NEW COUNTRY CLUB ESTATES SUBDIVISION, 7TH
UNIT, RESUBDIVISION OF LOT 30

APPLICATION NUMBER 3 DATE August 2, 2018
 APPLICANT New Country Club Estates Subdivision, Resubdivision of Lot 30
 REQUEST Subdivision

DETAIL SITE PLAN

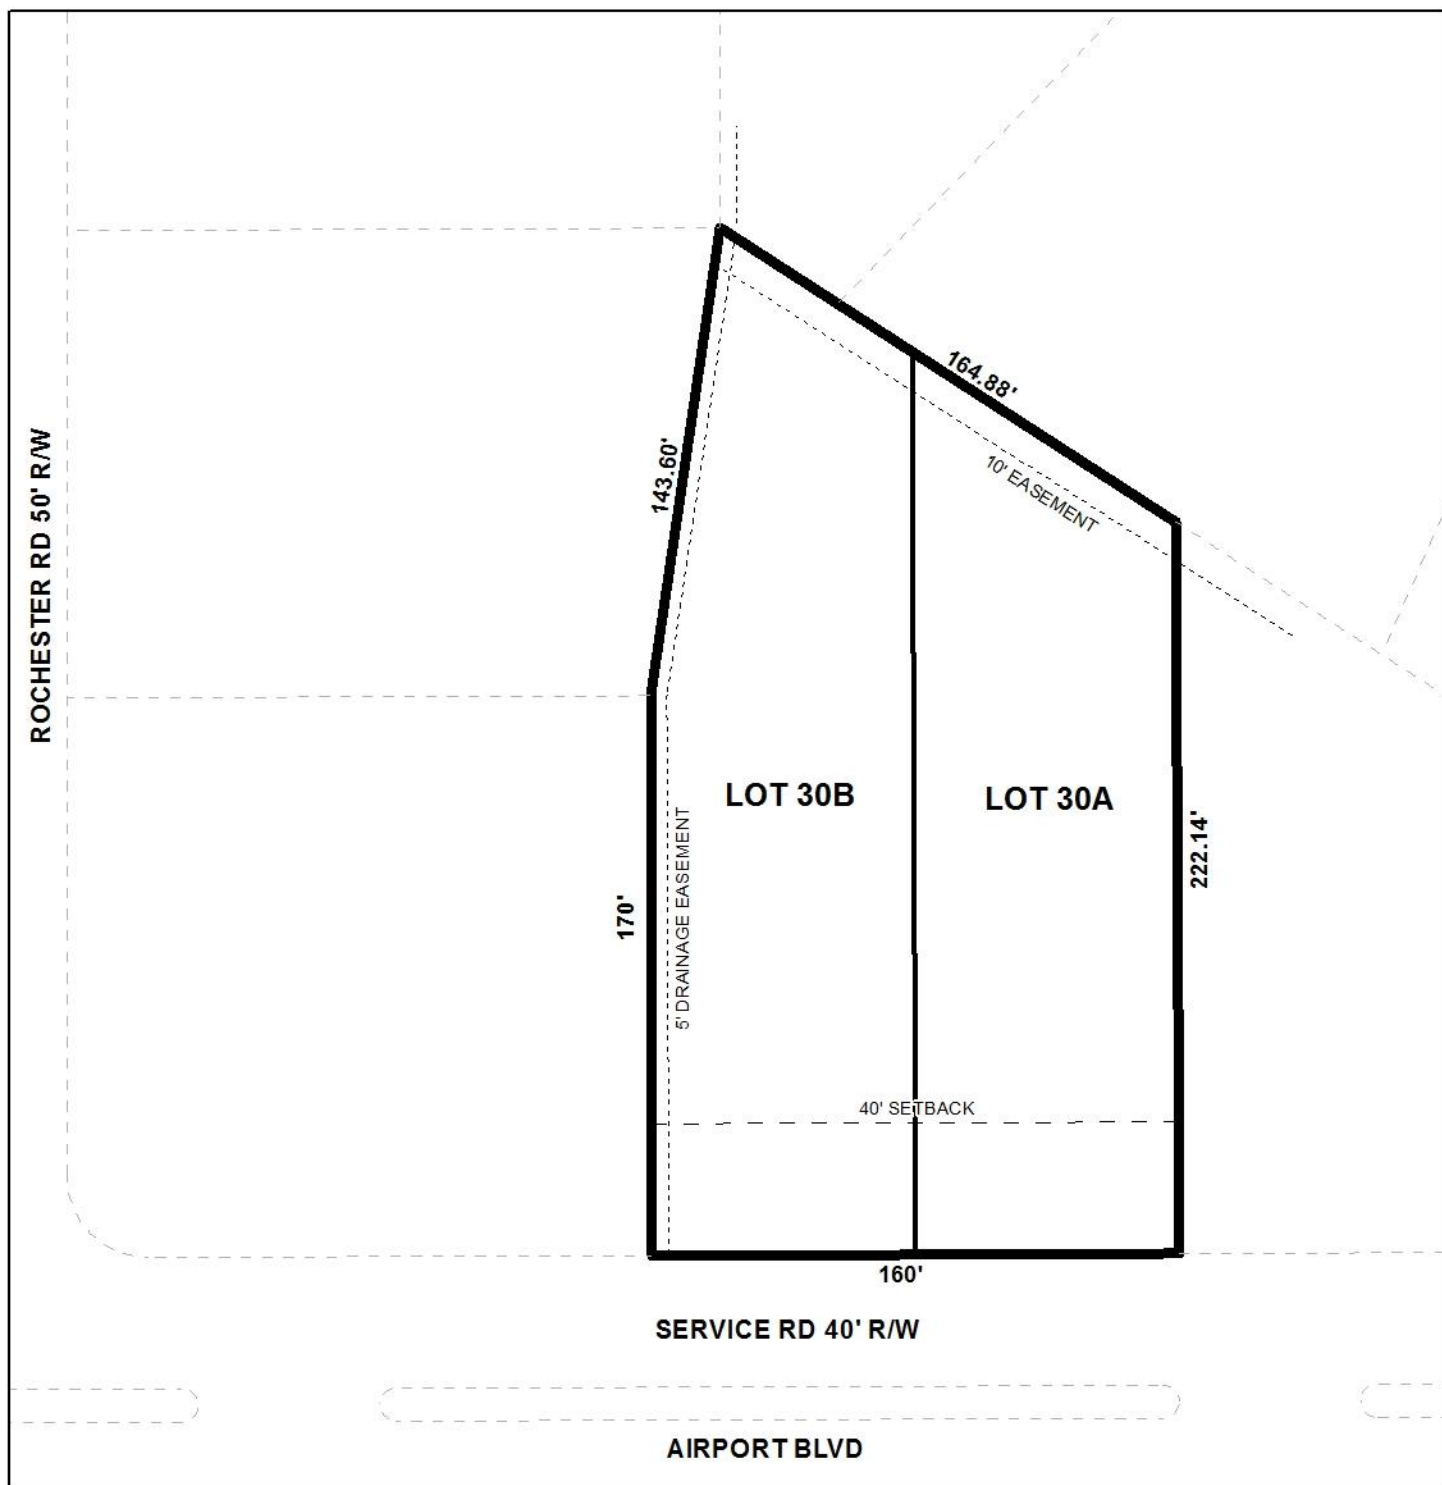
The proposed lots meet the minimum size and frontage requirements as regulated by Section V.D.2. of the Subdivision Regulations. However, Lot 30-B does not comply with Section V.D.3. of the Subdivision Regulations regarding the maximum width to depth ratio. As proposed, Lot 30-B exceeds the 3.5 width to depth ratio by roughly 33.6' (ratio= 3.9/313 feet vs 280 feet); and while the amount is not substantially larger than the requirements, the lot still exceeds the ratio. Thus, a waiver of Section V.D.3 will be required in order to approve the subdivision as proposed.

The site has frontage along Airport Boulevard Service Road. It appears that the right-of-way for Airport Boulevard and Airport Boulevard Service Road is sufficient, thus no dedication will be required. However, the total existing minimum right-of-way width for Airport Boulevard and the Airport Boulevard Service Road should be depicted and noted on the Final Plat.

As a means of access management, a note should be placed on the Final Plat, if approved, stating each lot is limited to one curb-cut with the size, location and design to be approved by Traffic Engineering, and conform to AASHTO standards.

Section V.D.9. of the Subdivision Regulations requires the provision of a 25' minimum building setback from the "front property line". The preliminary plat depicts the minimum building setback line as being 40'. Which, if approved, exceeds the minimum requirements. The building setback line should be depicted on the Final Plat.

With a waiver of Section V.D.3 of the Subdivision Regulations, the application is recommended for Tentative Approval, subject to the following conditions:

- 1) revision of the plat to depict the minimum existing right-of-way width for Airport Boulevard and Airport Boulevard Service Road;
- 2) depiction of at least a 25' minimum building setback line on the Final Plat;

- 3) retention of the lot sizes in square feet and acres;
- 4) placement of a note on the Final Plat stating each lot is limited to one curb-cut with the size, location and design to be approved by Traffic Engineering, and conform to AASHTO standards;
